SHILCO SUBDIVISION, LOT 1, RESUBDIVISION OF LOT 1

APPLICATION NUMBER 1 DATE June 3, 2010

DETAIL SITE PLAN

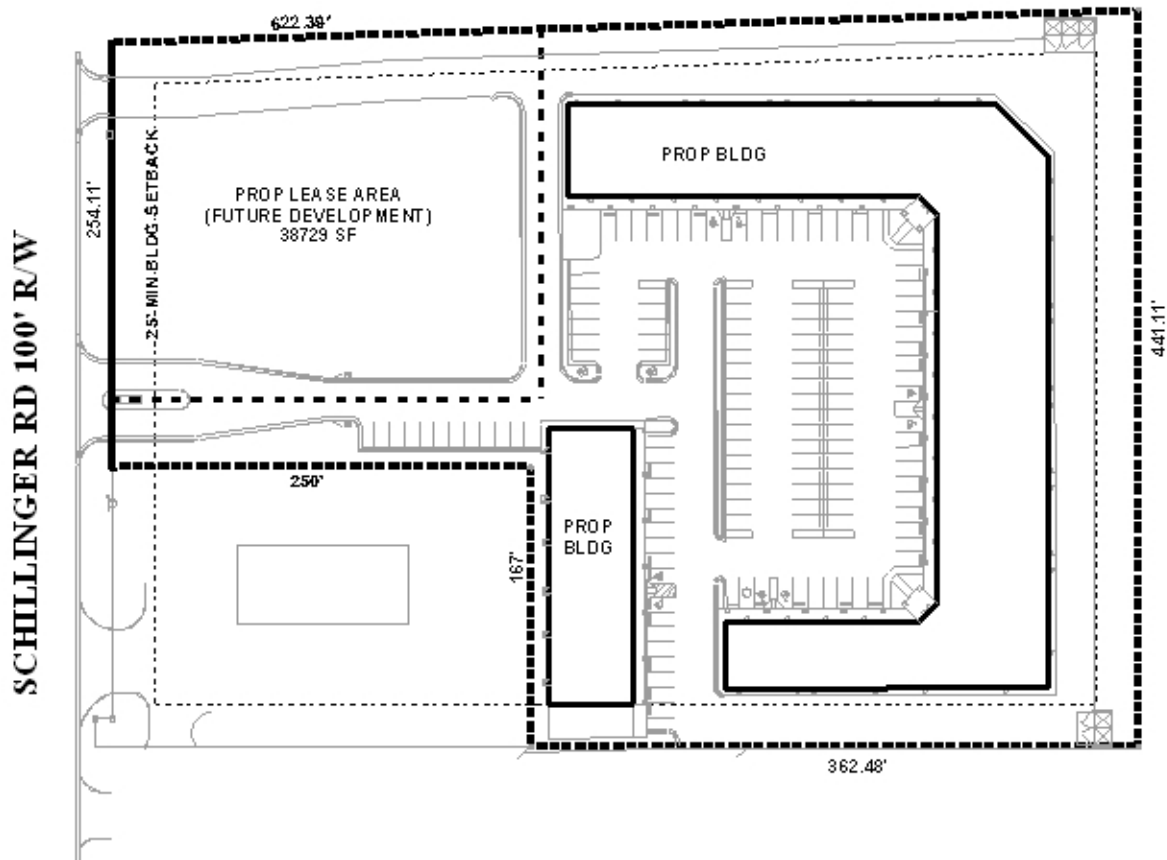
The plat illustrates the proposed 1-lot, 5.1± acre subdivision which is located on the East side of Schillinger Road South, 380'± North of Cottage Hill Road, in the Planning Jurisdiction. The applicant states that the subdivision is served by public water and sewer services.

The subject lot is part of a two-lot subdivision, Shilco Subdivision, Resubdivision of Lot 1, which was approved by the Commission in February, 2001. A condition of that approval was *"the placement of a note on the final plat stating that Lots 1 & 5 are limited to a total of two curb cuts to Schillinger Road, with the location and design to be approved by County Engineering."* Lot 5 is currently developed with one curb cut and the applicant proposes to develop Lot 1 with two curb cuts; therefore, the above-stated condition must be amended to allow a total of three curb cuts between the two lots. However, as that condition applied to both Lots 1 and 5 of the previously approved subdivision, both lots must be included in this subdivision, not just Lot 1. Therefore, this application cannot be considered as submitted.

- 1) the condition in question applied to both lots of the previously approved subdivision; and
- 2) both lots must be included in a subdivision application to amend the curb cut limitation condition.

- 1) the condition in question applied to both lots of the previously approved subdivision; and*
- 2) both lots must be included in a subdivision application to amend the curb cut limitation condition.*
